SEWAGE PERMIT APPROVAL

Property address: 448 No. 50th. Town of: Longview
Permit name: Ernest E. Kendall County of: Cowlitz
Section 12 Township 8N Range 3W Subdivision Reweys Clark Cr. Acres Lot 1 Block 3
APPROVED FOR: Two bedroom mobile home

Project No. 76-910

PLOT PLAN: Show the following

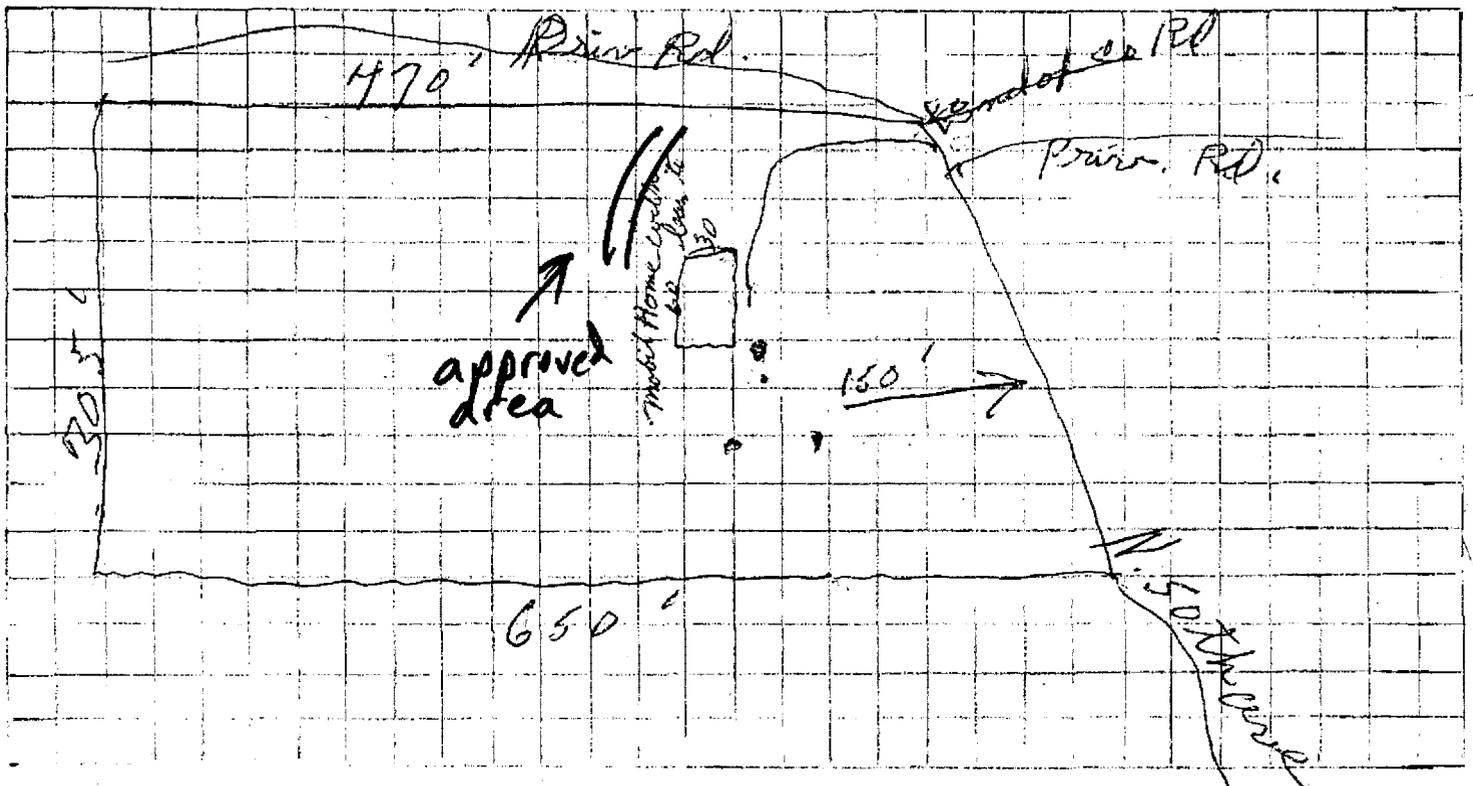
Other requirements: ① The drainfield lines shall follow the old cat road as indicated to you at your site. ② The trenches shall be approximately 6 1/2 to 7 feet apart, center to center, and shall be kept as close to the uphill side of the road as possible. ③ Trench bottoms shall be level. ④ All trees within 10 feet of the drainfield shall be removed.
